Subsequent Report

Type of Action: Plug and Abandonment

REID 25

PLUG AND ABANDONMENT

Current Schematic - Version 3

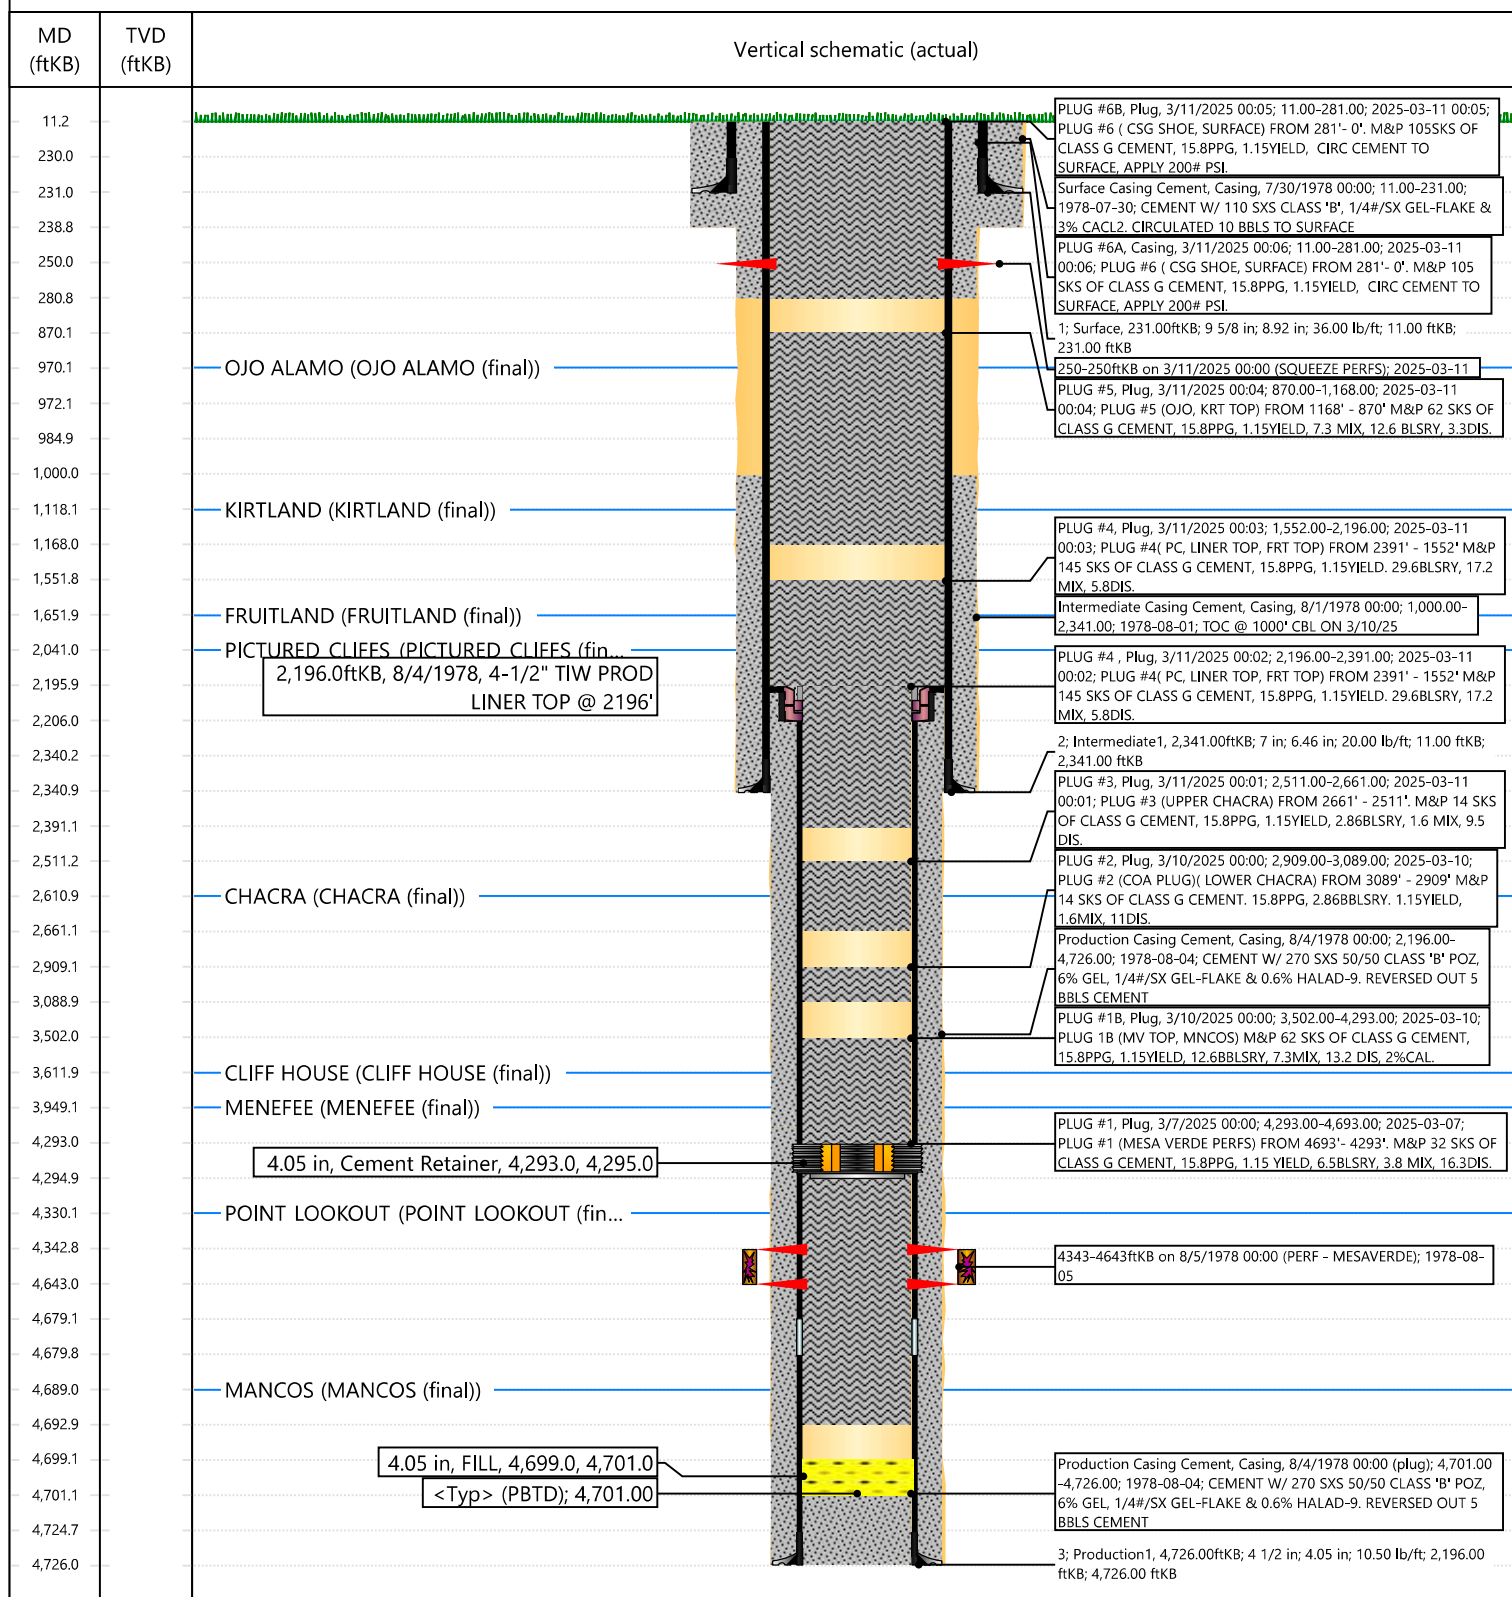
The BLM finds the proposed procedure appropriate. Please have plug 5 (Kirtland at 1118 and Ojo Alamo at 970) cover 1168 to 870 per the attached procedure. The email message indicates cement coverage is plan for only the Ojo Alamo from 1020 to 870.

NMOCD approves below with following exceptions and prior approval from the BLM

In plug 2 highlighted shows upper chakra at 6311 should be 2611(do not need to send another email)

CBL will have to confirm top of cement taken from temp log for plug 5 (Ojo plug) – perforations may change

Per our conversation, based on the CBL, we will no longer perf/squeeze the Ojo plug, and will instead pump a 150' balance plug from 1,020'-870' (this will combine the Kirtland and Ojo plugs). We will also move the surface shoe perforation up from 281' to 250' for a better chance at circulating. We will however, run tubing down to 281' and attempt to circulate from there so we will still have inside coverage 50' below the shoe. Updated procedure attached.

The BLM also concurs with the exceptions brought up by NMOCD. The BLM reserves the right to update the perforations for Plug 5 (Ojo Almas) based off the TOC from the CBL.
